RESPONSES TO COMMENTS

Stonestown Development Project

San Francisco Planning
Case No. **2021-012028ENV**
State Clearinghouse No. 2022040571

Date: April 24, 2024
Case No.: **2021-012028ENV**
Project Title: **Stonestown Development Project**
To: Members of the Planning Commission and Interested Parties
From: Lisa Gibson, Environmental Review Officer
Re: Attached Responses to Comments on Draft Environmental Impact Report for the Stonestown Development Project (Planning Department File No. 2021-012028ENV)

5-48 **FIGURE 2-26**
PROPOSED COMBINED SEWER SYSTEM PLAN (REVISED)

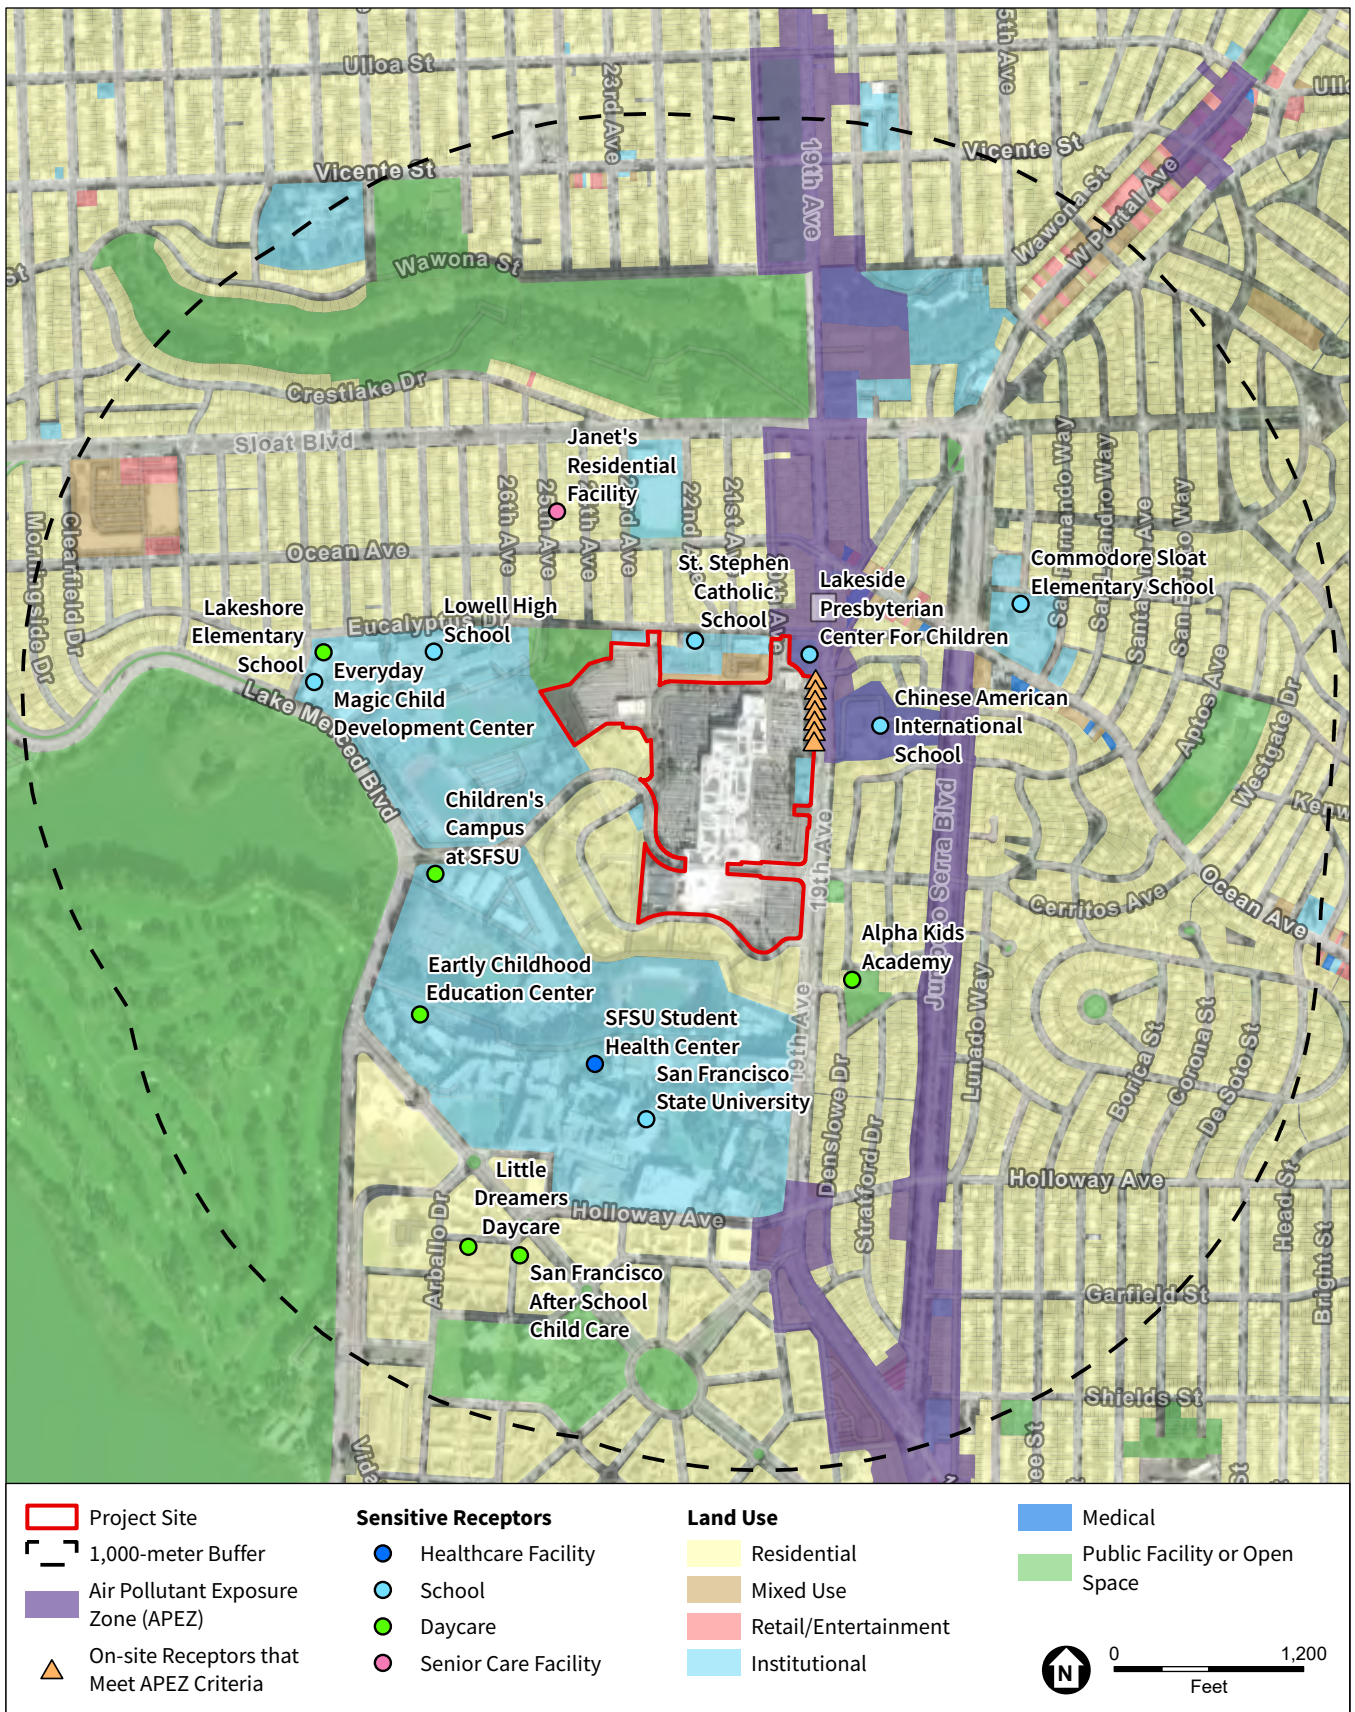
- Figure 2-22: the road approach and road connection off the State Highway System for the new streets
 - Figure 2-23: the new proposed water line within the limits of Caltrans’ Right of Way (ROW)
 - Figure 2-26: the new private sewer line within the limits of Caltrans’ ROW
 - Figure 3.B-4: the proposed sidewalks within the limits of Caltrans’ ROW” (*Yunsheng Luo, Associate Transportation Planner, California Department of Transportation, Letter, 2/8/23 [A-Caltrans-1, GC- CEQA-6]*)
-

The comment requests coordination of the proposed project design and construction schedule with Caltrans projects specified in the comment and identifies project elements depicted in draft EIR Figures 2-22, 2-23, 2-26, and 3.B-4 that would require a Caltrans-issued encroachment permit. The comment is acknowledged. The proposed project or variant would include the requested coordination of the project design and construction schedule with the identified Caltrans projects and coordination regarding the required encroachment permits. Also note that draft EIR Section 2.G, Required Project Approvals (see Section 2.G.1, State and Regional Agencies, California Department of Transportation, p. 2-47), identifies the Caltrans encroachment permit requirement.

FIGURE 3.D-1
SENSITIVE RECEPTORS (REVISED)

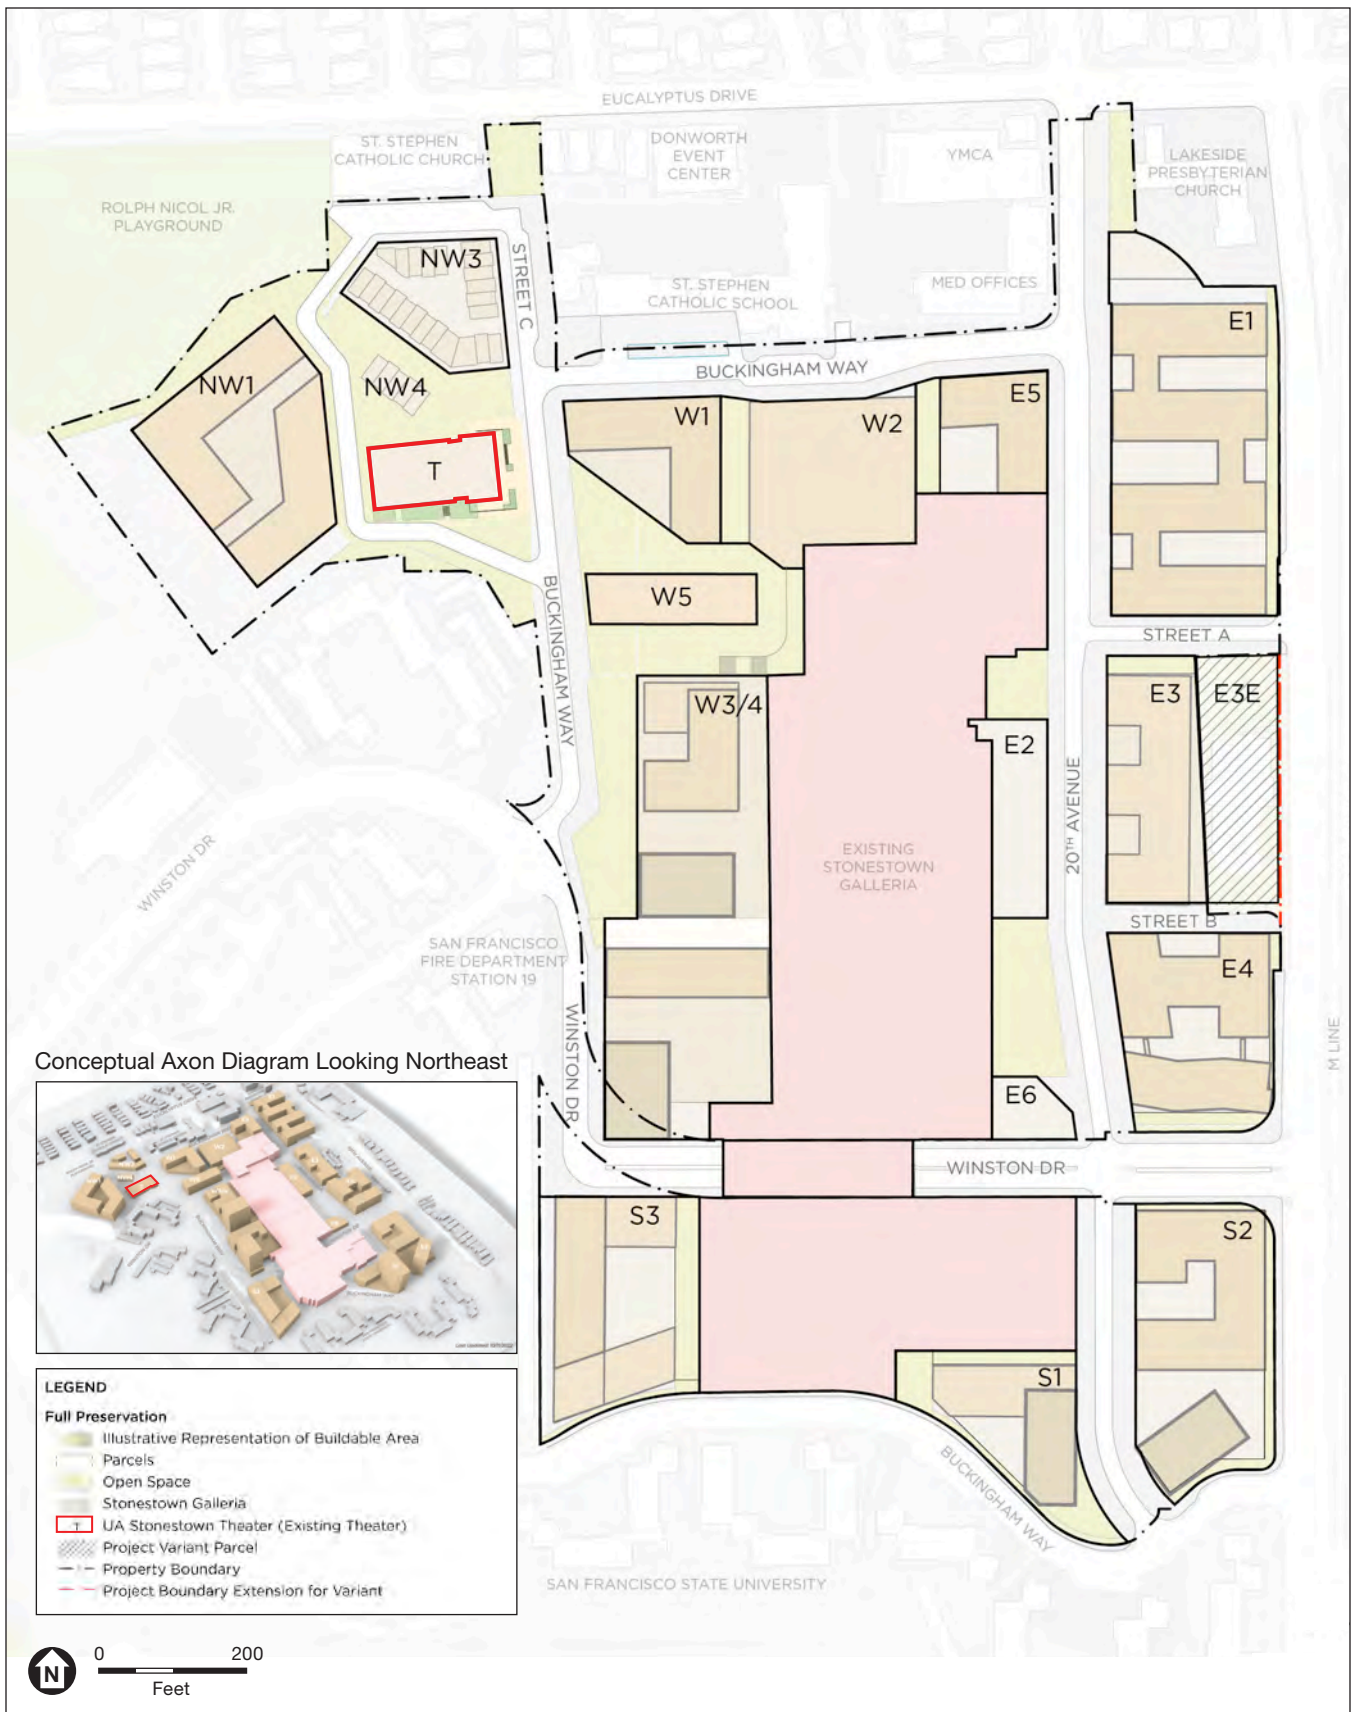
Page 3.D-13, paragraph 3. The last sentence of this paragraph indicates that ‘a small portion of the project site that borders 19th Avenue does meet the APEZ criteria’ but does not actually indicate where this small portion is actually located. Figure 3D.-1 on page 3.D-14 does not provide any information in this regard.

Page 3.D-14, Figure 3.D-1. Why is this land use map so different from the one presented in Figure 2-2 on page 2-5? There are literally dozens of differences between these two land use maps and leads the reader to wonder which is correct. This lack of consistency in the EIR is most troubling because it is not possible to clearly understand the analysis when basic information is not reliable.

Page 3.D-14, Figure 3.D-1. Although this land use map actually acknowledges commercial uses along Ocean Avenue (compare with Figure 2-2 on page 2-5), there are still a variety of land uses that are not correct on this figure. For example, what is the ‘commercial’ land use on 21st Avenue? What is meant by the ‘residential-mixed use’ designation? This is not explained in the EIR. I, for one, can assure you that my residence on 20th Avenue, which is designated as ‘residential-mixed use’ on Figure 3.D-1 is a single-family home with no other land uses associated with it. Given the number of such parcels identified on this figure as ‘residential-mixed use’ within residential neighborhoods, it undermines any confidence that the preparers of the EIR did their due diligence in preparing the document.” (Dave Full, Letter, 2/12/2023 [I-Full-28, AQ-1])

One comment identifies inconsistencies in land use types between Figure 3.D-1 on draft EIR p. 3.D-14 and Figure 2-2 on draft EIR p. 2-5. In response to the comment regarding the location of the APEZ, the commenter is correct that neither the draft EIR text nor Figure 3.D-1 on draft EIR p. 3.D-14 indicate the specific location of receptors that meet the APEZ criteria, only that a small portion of the project site that borders 19th Avenue does meet the APEZ criteria. To respond to this, Figure 3.D-1 was revised to show the locations of the receptors that do not meet the APEZ criteria, which are located at the northeast portion of the site.

Regarding the differences between Figure 2-2 on draft EIR p. 2-5 and Figure 3.D-1 on draft EIR p. 3.D-14, the commenter does not identify any specific differences. The commenter could be referring to institutional land uses, which are different on the two figures. Figure 2-2 on draft EIR p. 2-5 shows the SFSU student housing as institutional; Figure 3.D-1 on draft EIR p. 3.D-14 shows the SFSU student housing as residential. This is because for the purposes of the health risk assessment, all SFSU student housing is conservatively considered residential. As explained in Response PD-1, p. 4-5, Figure 2-2 is intended to be a high-level general land use map indicating primary uses in the area and does not necessarily correspond to the detailed zoning district designations. However, Figure 2-2 on draft EIR p. 2-5 has been updated to respond to the commenter and is provided on p. 5-31 of this RTC document. In response to a comment regarding potential errors in Figure 3.D-1 on draft EIR p. 3.D-14, the commercial land use classification for the parcel on 21st Avenue near Sloat Boulevard is in fact a single-family residence. Figure 3.D-1 was corrected to show this as a residential land use type. Figure 3.D-1 has also been revised to separate “Residential” and “Mixed Use” designations. The Mixed Use designation refers to parcels that may include both residential and retail/commercial land use types. This does not affect the analysis, as these mixed-use receptors were conservatively analyzed as residential. **Revised Figure 3.D-1** is provided on p. 5-49.
